CHESHIRE WEST AND CHESTER COUNCIL

Frodsham Solar DCO - EN010153

Cheshire West and Chester Council's comments on (extant) Procedural Deadline B documents, Deadline 1 and Deadline 2 submissions

submitted at Deadline 3 – 28 January 2026

Extract of Fig 7 from APPENDIX 8.4 –
GEOARCHAEOLOGICAL DESKBASED ASSESSMENT
Runcorn Carbon Dioxide Spur Pipeline Proposed
Development (Appendix C of CWCC's Written Representations [REP1-048])

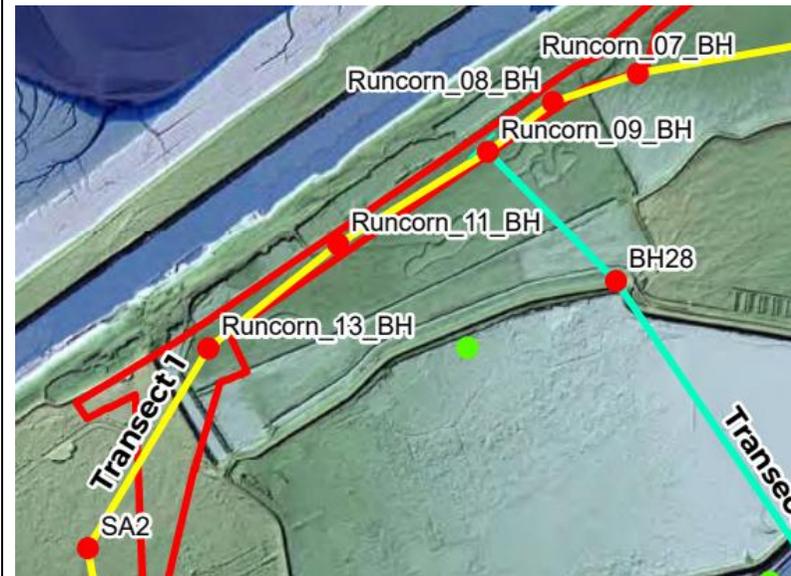
<p>with green halos positions below 2m (includes Runcorn_08_BH, Runcorn_09_BH, Runcorn_013_BH, BH28, BH29 and SJ47NE14). Peat has not been encountered within 2 metres of the existing ground surface.</p> <p>3.7 Based upon the proven peat distribution on Figure 3.1, which identifies positions where shallow peat (within 1.2 metres of the current ground surface) is encountered in the Blue coloured positions with red halos, the potential for interaction of drainage or duct excavations and groundworks, in the areas outside the SADA and NBBMA, is limited though potentially may occur to the south west of the NBBMA. This interpretation is generally consistent with the interpretation proposed within the Geoarchaeology Assessment undertaken for the Runcorn Carbon Dioxide Spur Pipeline Development [Planning Application reference 25/02108/FUL].</p>	<p>Carbon Dioxide Spur Pipeline Proposed Development (Appendix C of CWCC's Written Representations [REP1-048]. See extracts below.</p> <p>Whilst the boreholes indicate that the peat deposits are between 5-10m below current ground levels, it is notable that the depth and the thickness of these peat layers vary over a relatively short distance along the transect. The point being that knowledge of variances in peat deposits in the NBBMA, where there will be extensive re-engineering works, may require further investigation/assessment, although it is also acknowledged that the majority of the exploratory locations in the NBBMA revealed no peat.</p> <p>Fig 4.1 of the technical note shows areas of potential further investigation, and whilst the canal pools along the northern side of the NBBMA are included, it is notable that no further reference is made in relation to the NBBMA. Given the extent of engineering work proposed on the NBBMA, intentionally bringing less permeable soils nearer the surface, it is considered that a Peat Management Plan for the NBBMA would be appropriate.</p> <p>Peat deposits in the NBBMA that may be currently at greater depth than 5m, are liable to have excavations above that would temporarily or otherwise bring the deposits closer to the surface. This may not be an issue, but further clarity from the Applicant regarding the assessment of the impact of the re-engineering works within the NBBMA on potential peat deposits would be welcome, especially in relation to compaction from earthworks. It appears that potential impacts may be greater than for other areas, such as the SADA, due to the large-scale excavation (cut and fill) exercise to form the NBBMA; as well as some peat deposits being present at 5m-10m depth.</p> <p>In general, i.e. not just to satisfy concerns about peat deposit, greater detail of the proposed engineering works to the NBBMA soils (e.g. in terms of how the composition of the soils would be altered) and establishment of parameters for works in the NBBMA (e.g. in terms of limits on depth of excavation) should be provided.</p> <p>The Water Balance Update Report (Annex 4 of the NBBMS within the oLEMP [REP1-028] contains the drawing GM12793-007 Rev A (Proposed Levels Option 2), and this shows proposed cut and fill along with sections.</p>

It is understood that this is a conceptual model, and it does not depict provision of the water storage area on the northern embankment to Cell 3. It is understood that the water storage area is proposed, not least as this would add resilience to the adaptive water management for the NBBMA. Clarification from the Applicant regarding the provision of a water storage area and its parameters e.g. location (viz-a-viz) the SSSI should be provided.

Extract of Transect 1 from APPENDIX 8.4 –
 GEOARCHAEOLOGICAL DESKBASED ASSESSMENT
 Runcorn Carbon Dioxide Spur Pipeline Proposed
 Development (Appendix C of CWCC's Written Representations [REP1-048])

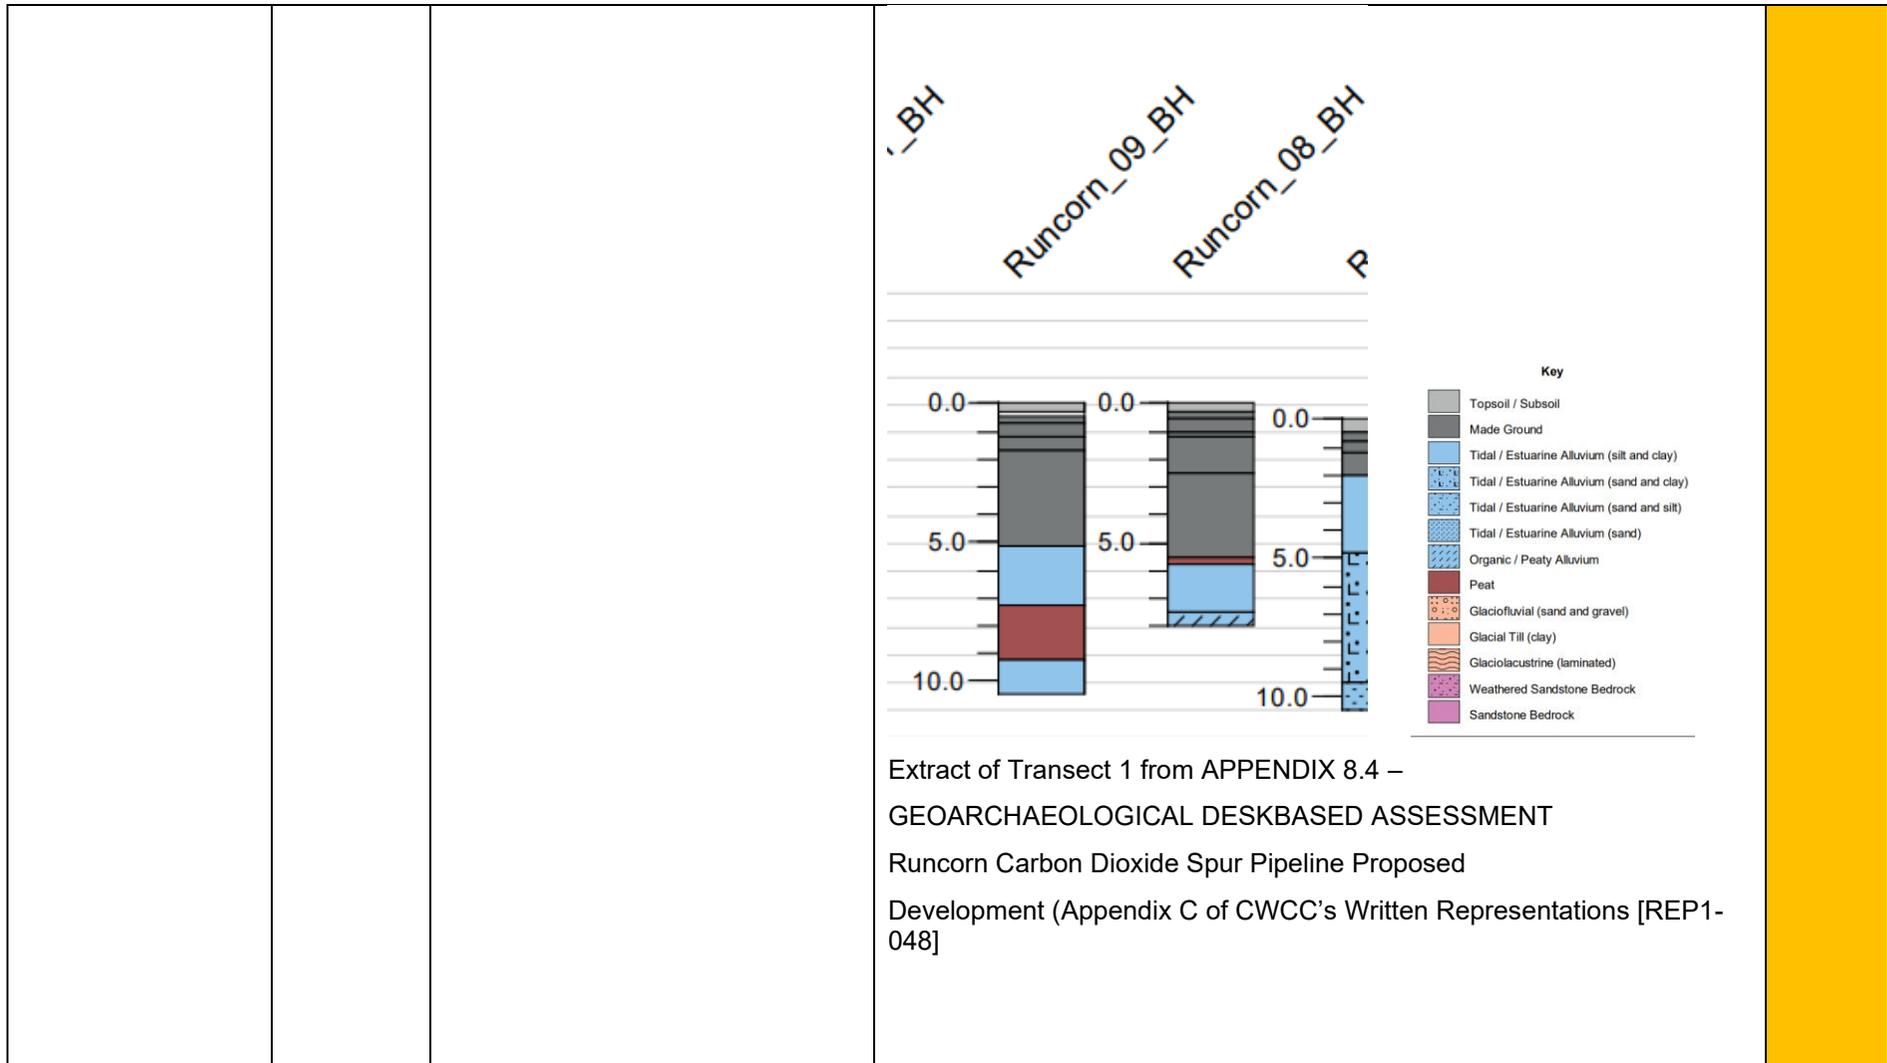
Re-engineering of the soils is proposed to form the NBBMA, and
